STAFF REPORT CORRECTED 7-26-84
CITY PLANNING COMMISSION

- APPLICATION:
- A. Negative Declaration
 - B. Amend Sutterville Heights Community Plan from Light Density Residential to Shopping Commercial;
 - C. Plan Review for a portion of a 23,000± sq. ft. retail commercial building;
 - D. Lot Line Merger to create one parcel.

PROPOSAL: The applicant is requesting the necessary entitlements to merge three parcels into one parcel and develop a 23,760± square foot commercial shopping area to be known as Pacific Village.

SITE PLAN

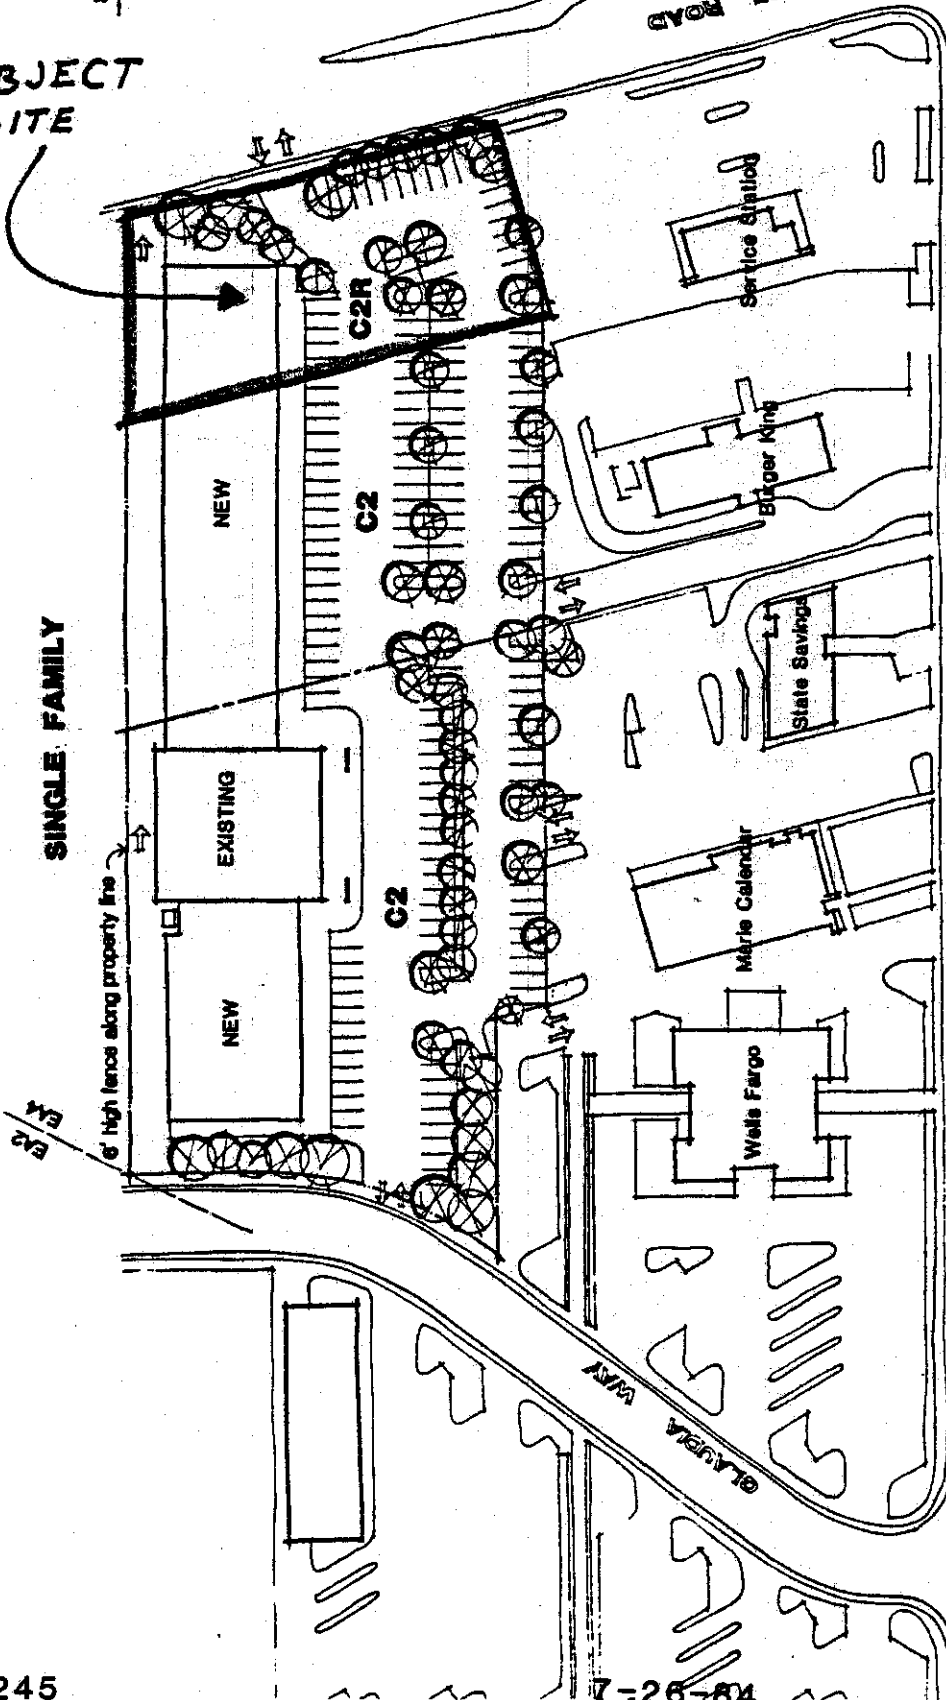
3. The applicant's plans indicate a single story building consisting of wood and concrete with a metal roof. A six-foot high masonry wall will separate the site from the adjacent residences to the west. A 15 foot alley will be located to the rear of the proposed building and adjacent to the residential area. The alley will be used for and by delivery trucks.

There are no major objections to the proposed plans; however, some minor additions should be made, these include:

- a. Location and construction of trash enclosures should be in accordance with the criteria outlined in Exhibit F.
 - b. Landscape and irrigation plans should be submitted for review and approval.
 - c. A sign program should be submitted for review and approval.
4. The project was reviewed by the offices of the Public Works Director, Traffic Engineer and Building Department. The following comments were received:

- a. East driveway on Fruitridge Road must line up with existing driveway and must have 50-foot minimum 90 degree approach to street;
- b. West driveway (alley) must be at least 10 feet from property line, plus three feet of 'curb flare' on both streets;
- c. Claudia Way driveway must be 90 degrees (or radial) to center line. Eliminate first two stalls on east;
- d. Clarify what happens to existing driveway at east property line on Claudia Way.

- a. Applicant will need to provide reciprocal access easements across parcels. Also, possible reciprocal sewer and drainage easements will be required, depending on development plan.

- 1. The applicant shall comply with requirements of the City Traffic Engineer.
- 2. The applicant shall submit a detailed landscape, irrigation and shading plan to the Planning Director for review and approval prior to issuance of a building permit.

- 3. The applicant shall construct a six-foot high solid decorative masonry wall along the west property line.
- 4. The applicant shall comply with the design criteria for trash enclosures as outlined in Exhibit F.

- 5. The applicant shall provide reciprocal access easements across all parcels. Reciprocal agreements shall be submitted to and reviewed by the Planning staff prior to issuance of building permits.

- 6. The applicant shall comply with requirements of the Public Works Director pertaining to reciprocal access easements and reciprocal sewer and drainage easements.

- 7. The applicant shall submit a sign program to the Planning Director for review and approval prior to the issuance of sign permits.
